TIMBERLANE WOODS SUBDIVISION, UNIT ONE

APPLICATION NUMBER 6 DATE November 17, 2005
APPLICANT Timberlane Woods Subdivision
REQUEST Subdivision

TIMBERLANE WOODS SUBDIVISION

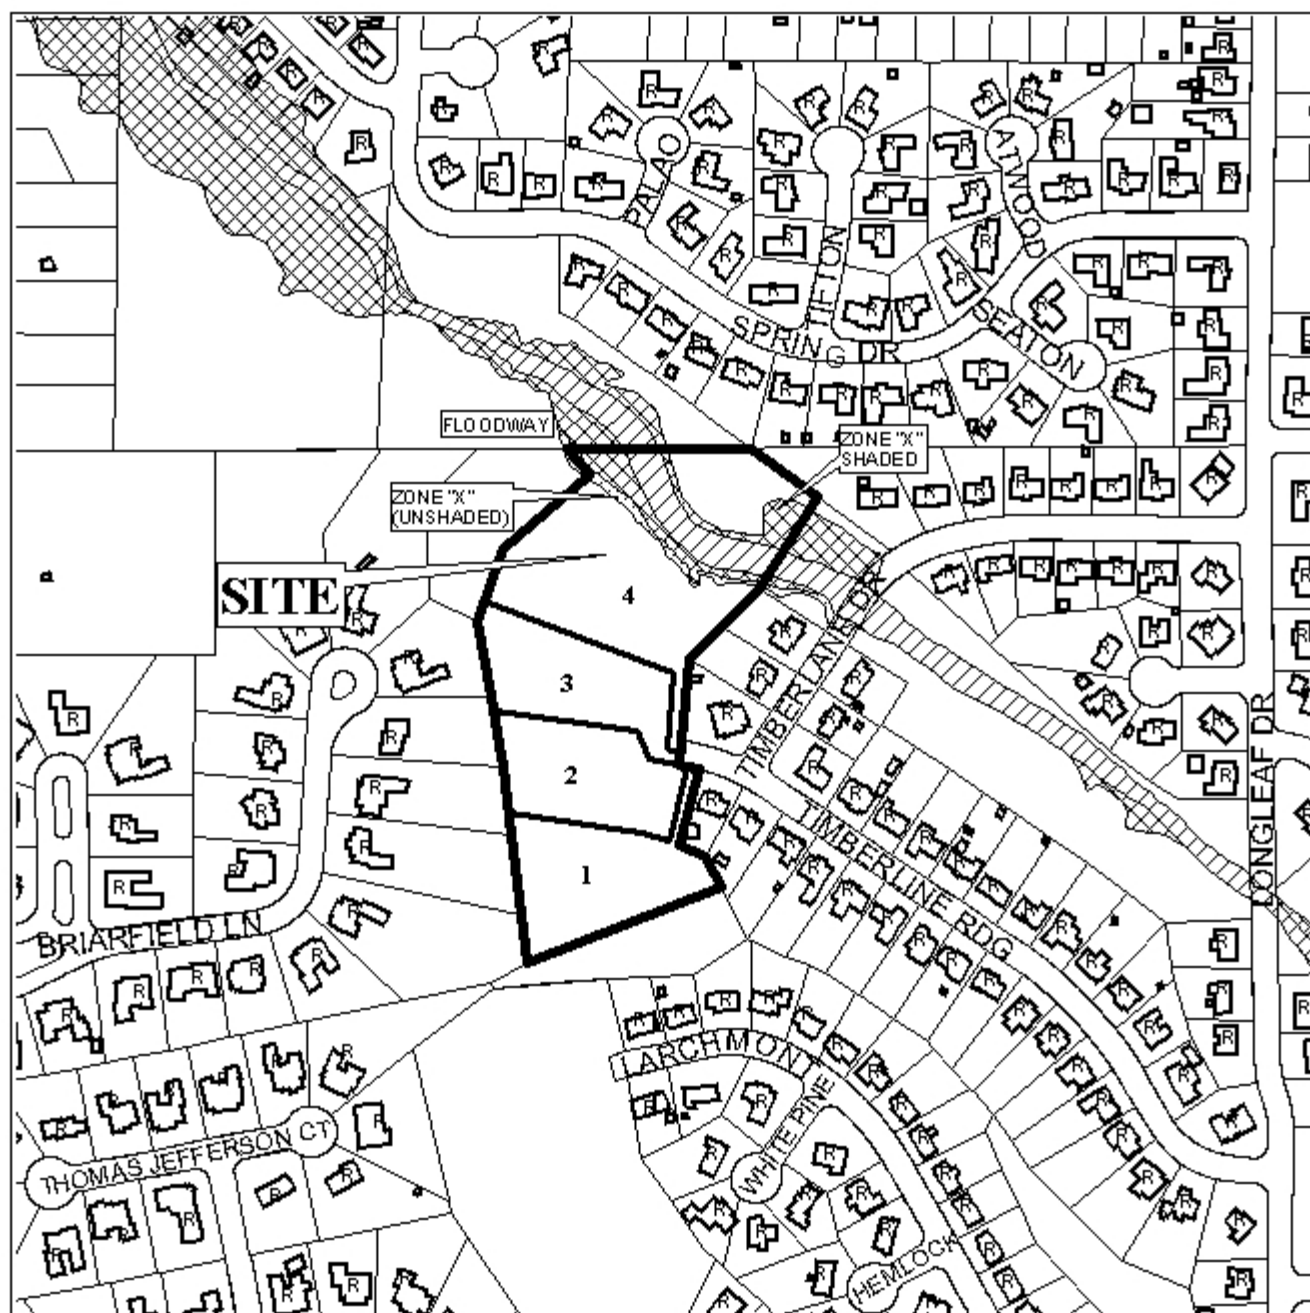
The 25-foot minimum building setback lines are not shown but would be required on the final plat.

As indicated on the plat, the site shows two of the lots as flag-shaped, which exceeds the depth to width ratio recommended in Section V.D.3. of the Subdivision Regulations. Furthermore, the flag-shaped nature of the proposed lots is uncharacteristic of other properties in the area and thus not in conformance with Section V.D.1. of the Subdivision Regulations. Additionally, in January 2005, the Commission approved this site for 33 lots with a modified turnaround/cul de sac.

Based on the preceding, the application is recommended for Holdover until the December 1st meeting to allow the applicant time to submit a revised plat showing no flag-shaped lots and a modified turnaround/cul de sac.
